HARRIMAN
UTILITY
BOARD

SANITARY
SEWER LINE
RELOCATION

HARRIMAN UTILITY BOARD
FORCE MAIN INSTALLATION
BAUMGARDNER STREET TO BREEZEALE STREET

10" FORCE MAIN
RELOCATION

PROFILES
SCALE AS SHOWN

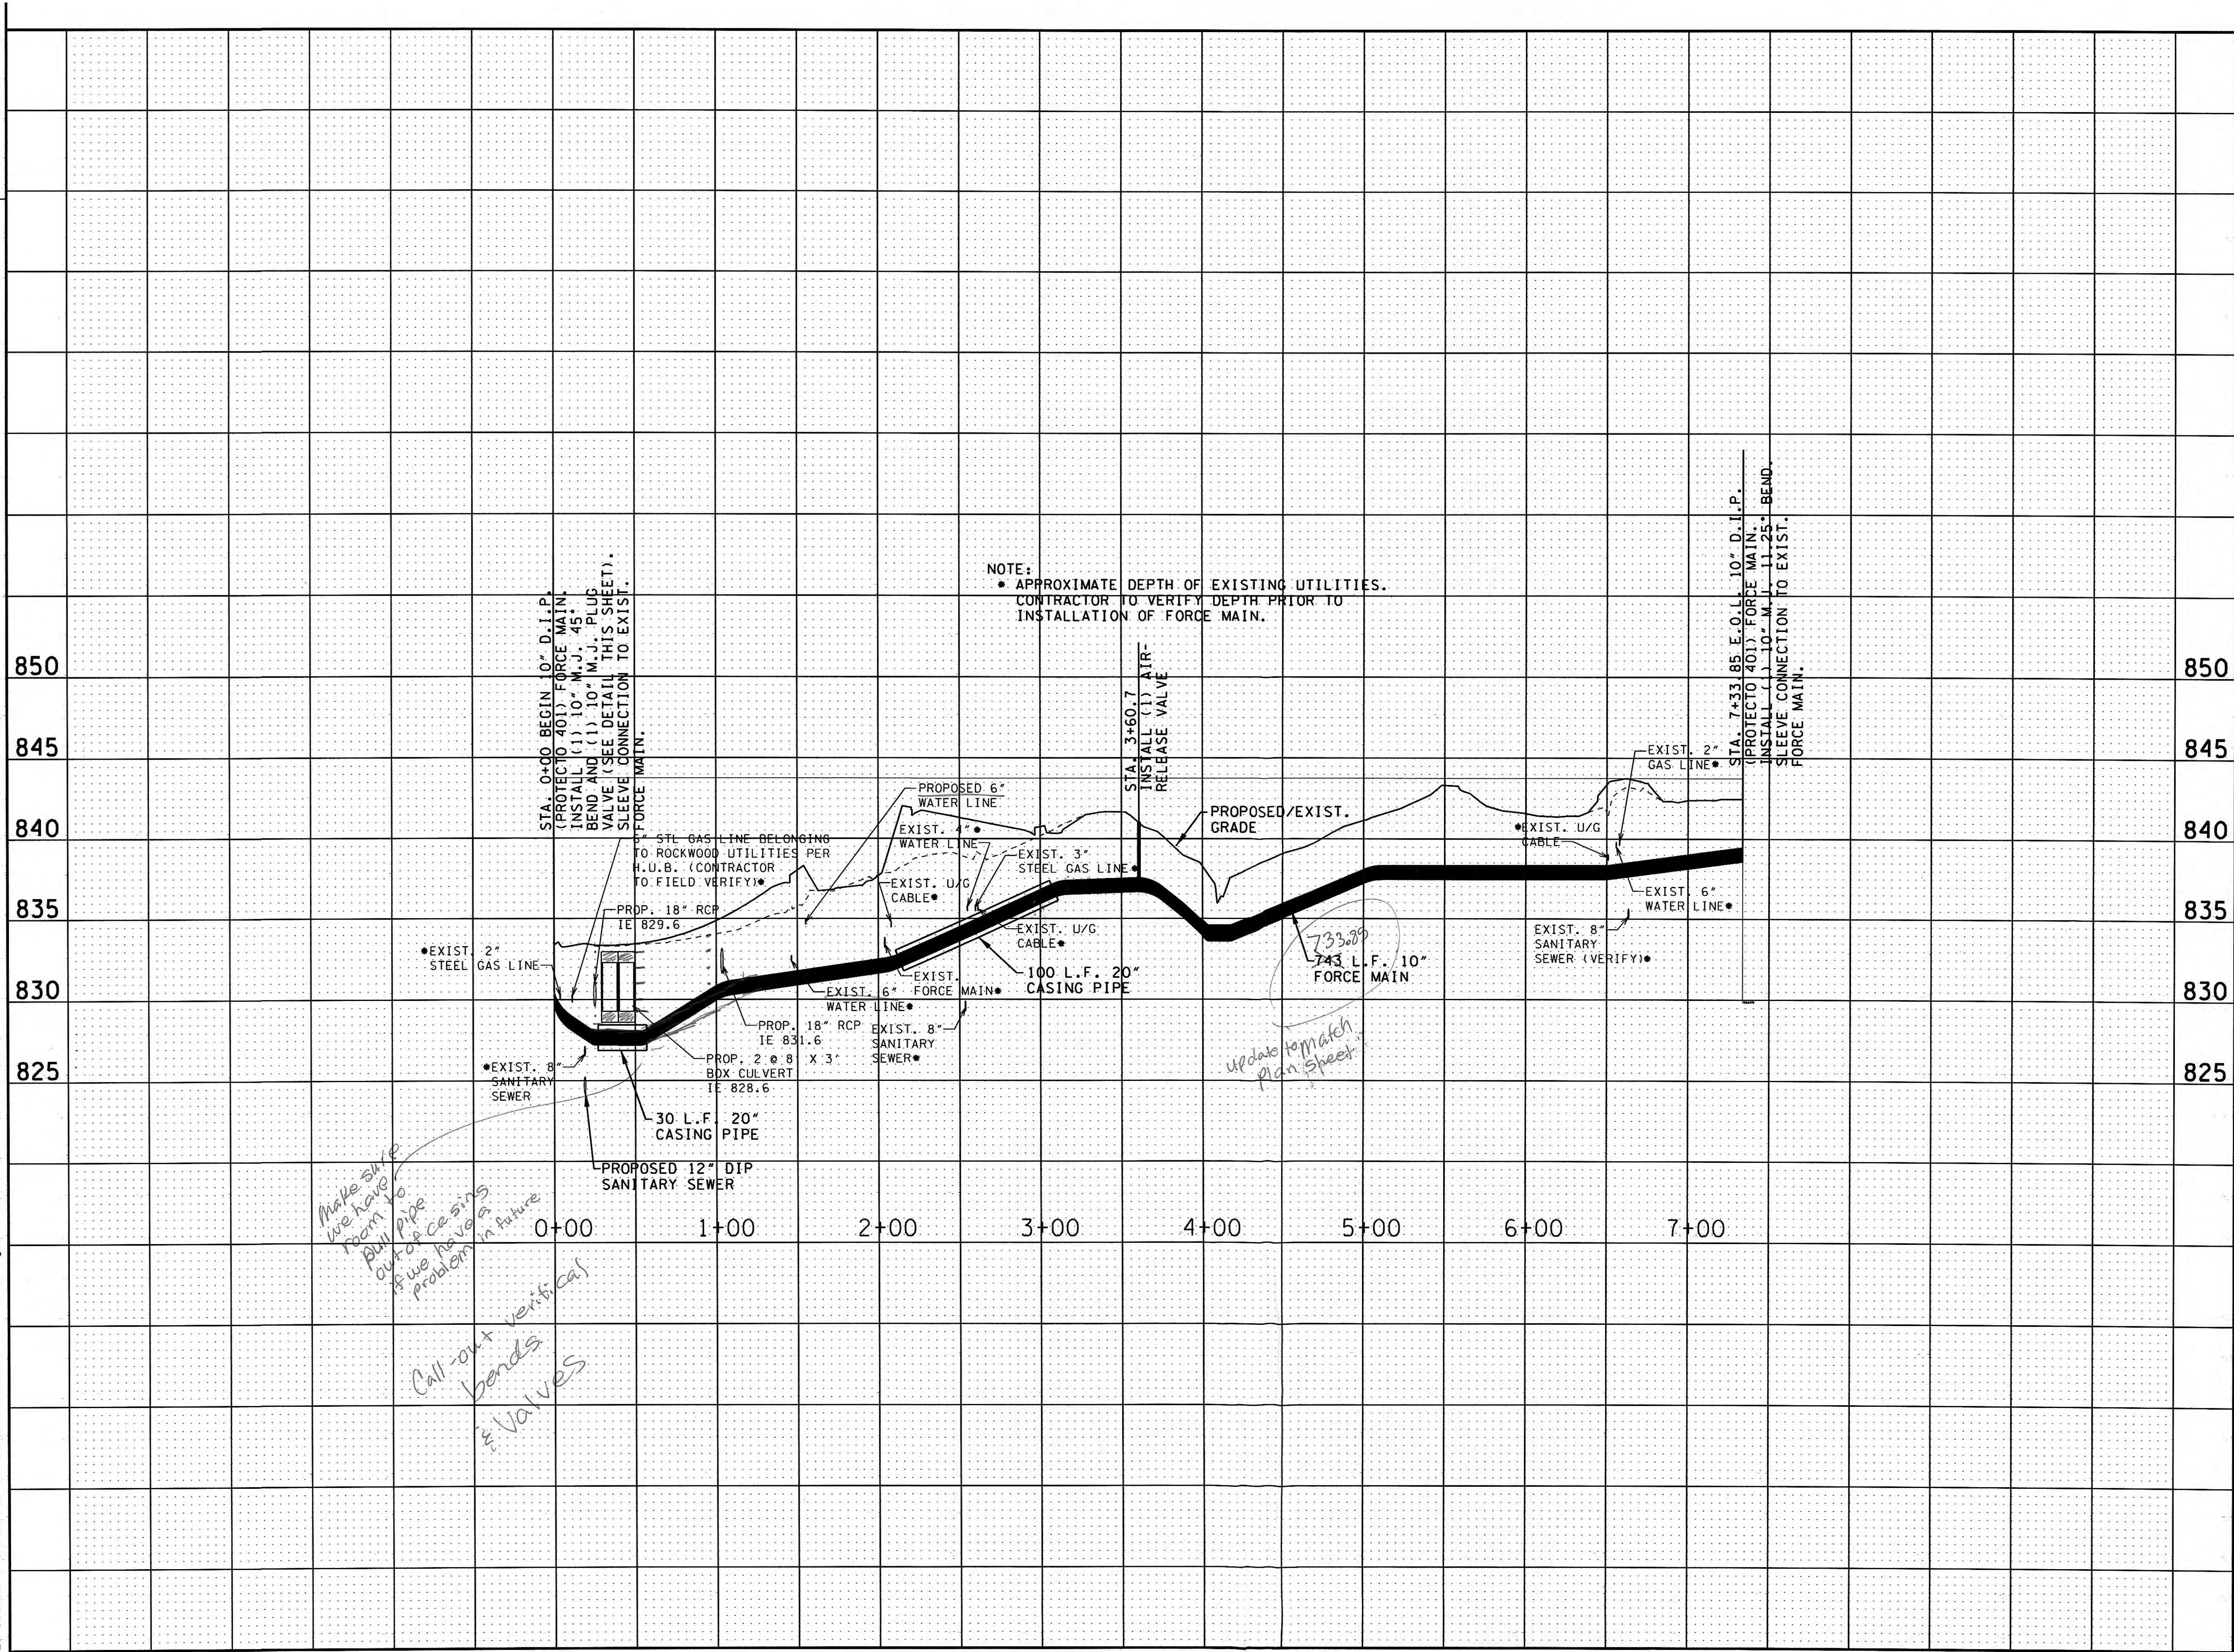
Are we on Church
property or grocery
store?

Call out all
horizontal/
vertical fittings
that are needed
No electro fuse
couplings

7
distinguish
b/w existing
& proposed
utilities & storm
lines we know which
lines will "go away"

Need fusing
specs (large diameter for us...)
check JWS
certification.
